Re: Peaches Fitness Club
4805 All Saints Rd. NW Albuquerque, NM 87120
Traffic Circulation Layout
Engineer's Stamp XX-XX-XX (C13-D016D)

Based upon the information provided in your submittal received 10-17-25, the above referenced plan cannot be approved for Building Permit until the following comments are addressed:

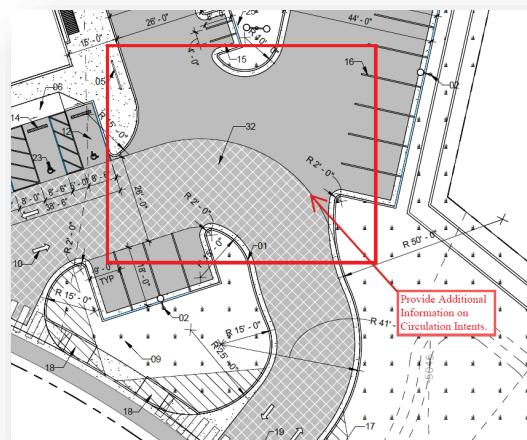
2. Identify all existing access easements and rights of way width dimensions.
3. Show roadway and identify the right of way width, curb cuts, and street widths on All Saints Rd. and High Assets Way.
4. Clarify existing property lines and proposed property lines.
5. Provide each driveway accesses width and detail drawings.
6. We notice callout 32. What are the site circulation intentions? Provide details for internal street path of travel.

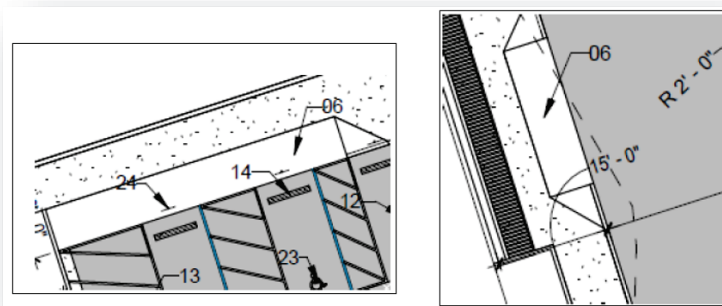
12. All sidewalks along streets should be placed at the property line.
13. Curbing should be installed to delineate landscape, parking, and pedestrian ways and identify points of access. Please call out detail and location of barrier curb.

14. Sidewalk must meet City standard drawing 2430. Callout all sidewalk dimensions and provide details.
15. All accessways to the site from the adjacent roadway shall be ADA-compliant.

16. Provide design details and City standard drawings for all ADA ramps.
17. Provide additional ADA ramp details on site plan. Show where ADA ramps vs sidewalk will be located and provide sidewalk widths.

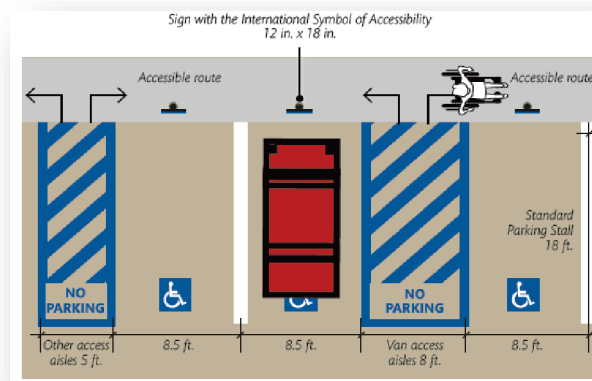
18. Dimensions, design, and stripping on site plan for ADA parking does not match detail drawings 2 and 3, sheet AS502. Please verify and correct as needed.

19. ADA access aisles shall have blue diagonal striping and the words **"NO PARKING"** in capital letters, each of which shall be at least one foot high and at least two inches wide, placed at the rear of the parking space so as to be close to where an adjacent vehicle's rear tire would be placed (66-1-4.1.B NMSA 1978). White paint is called out in detail drawing. Please correct detail drawing as needed.

FIGURE 7.4.115 Bicycle Parking Stall Layout Options

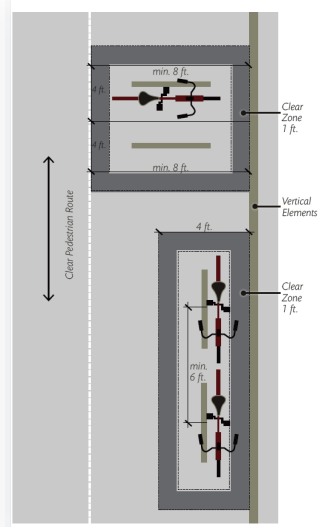
26. Provide electric vehicle pavement marking "EV" for each electric vehicle parking space.
27. Provide bicycle stall design details. Bicycle parking spaces shall be located, sized, and constructed as required by IDO. Ensure that a minimum 4 foot clear pedestrian access route width is free and clear from obstruction and protruding objects.

28. All bicycle racks shall be designed according to the following guidelines:
- The rack shall be a minimum 30 inches tall and 18 inches wide.
 - The bicycle frame shall be supported horizontally at two or more places. Comb/toaster racks are not allowed.

- The rack shall be designed to support the bicycle in an upright position. See the IDO for additional information.

- The rack allows varying bicycle frame sizes and styles to be attached.
 - The user is not required to lift the bicycle onto the bicycle rack.
 - Each bicycle parking space is accessible without moving another bicycle.
29. Bicycle racks shall be sturdy and anchored to a concrete pad.
30. A 1-foot clear zone around the bicycle parking stall shall be provided.

31. Bicycle parking spaces shall be at least 6 feet long and 2 feet wide.
32. Refuse vehicle maneuvering shall be contained on-site. The refuse vehicle shall not back into the public right of way.
33. Provide a copy of Solid Waste and Fire Marshal approvals.
34. Curbing should be installed to delineate landscape, parking, and pedestrian ways and identify points of access.
35. Show all private infrastructure outside of public right-of-way and all public infrastructure within public right-of-way. Any private infrastructure that is allowed by the City of Albuquerque to be kept within right-of-way shall require a revocable permit.
36. Show location of overhead utility lines in relationship to the buildings.
